# North Dakota Department of Transportation

## ADDENDUM 2 – JOB 30

TO: All prospective bidders on project IM-8-029(165)063, Job No. 30, scheduled for the October 9, 2015 bid opening.

Sheet 20-2:

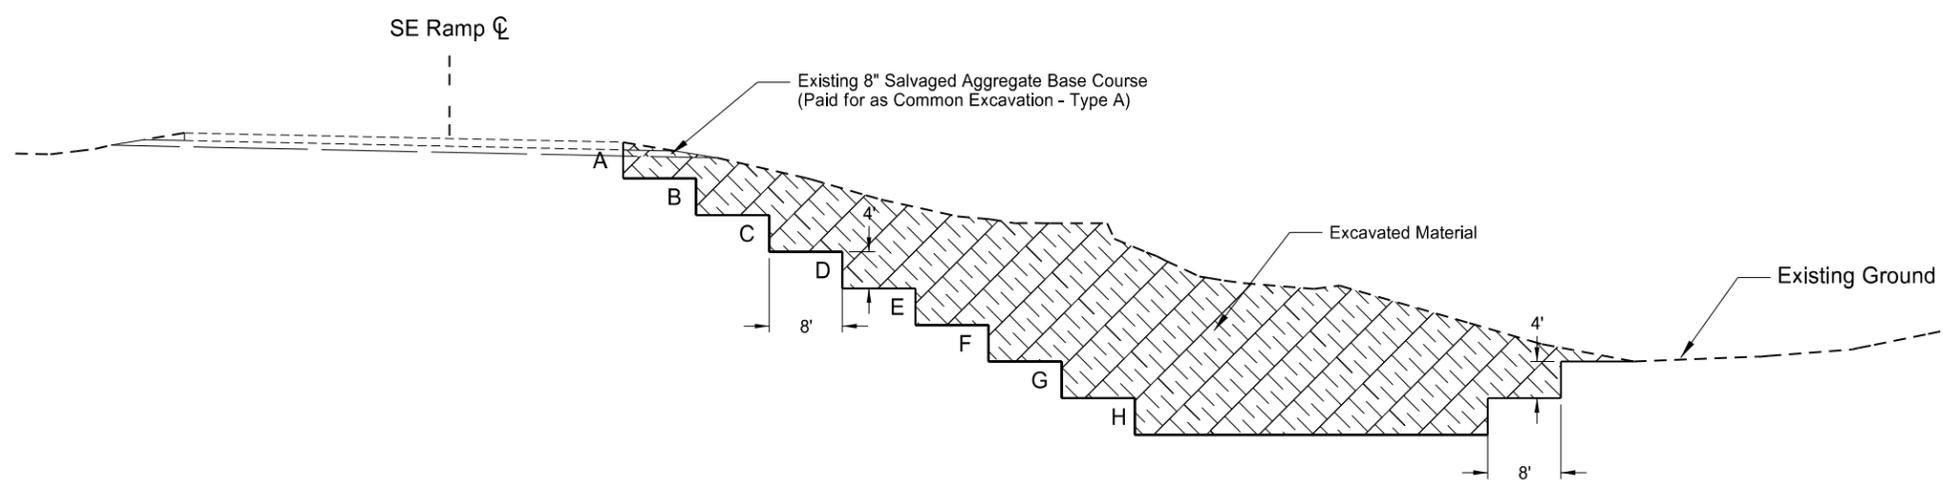
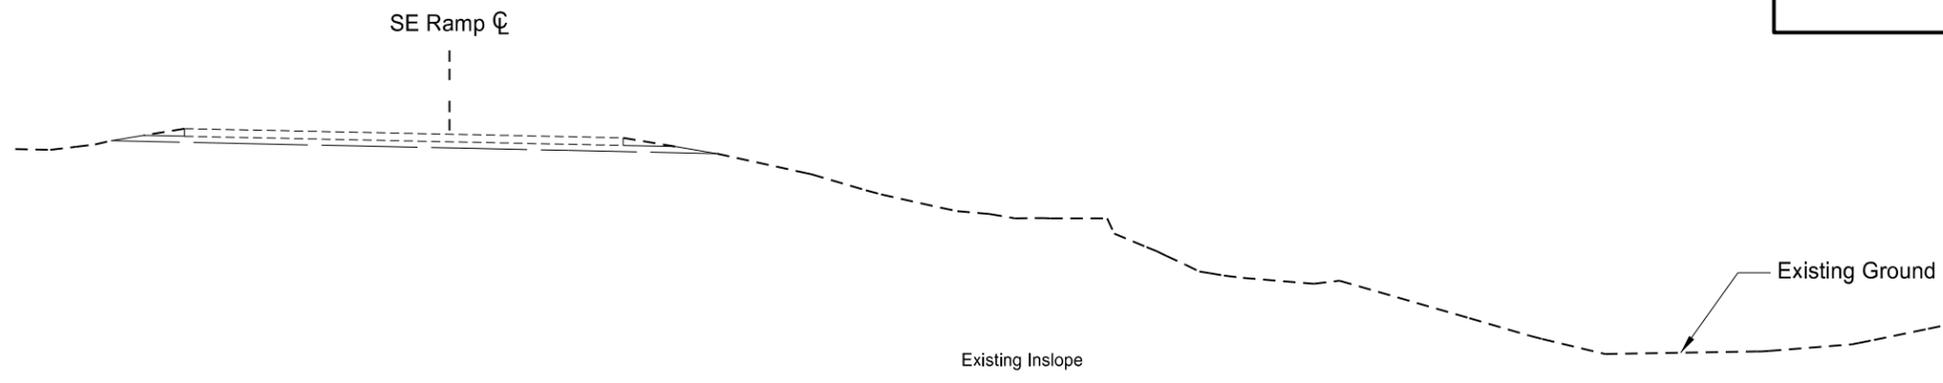
Changed the dimension that states, "Extend Geogrid out to a 1' minimum cover" to "Extend Geosynthetic Material Type R1 out to a 1' minimum cover".
